SUNDRY NOTICES AND REPORTS ON WELLS

Mescalero Ridge Unit 35 – 13 Merit Energy Company March 26, 2008 Plug and Abandonment Conditions of Approval

Permanent Abandonment of Federal Wells **Conditions of Approval**

DEVON ENERGY CORPORATION WELLBORE SCHEMATIC

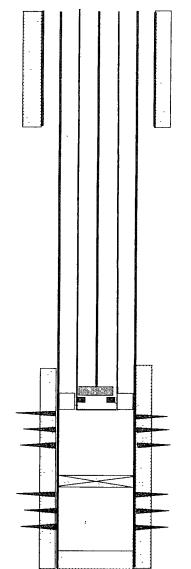
- 0. On future P&A procedures, include current and proposed schematics.
- 1. WOC and perform pressure test of plug to be done after placing cement to verify that perforations are sealed.
- 2. Ok
- 3. Ok
- 4. Ok
- 5. In addition, clean location.
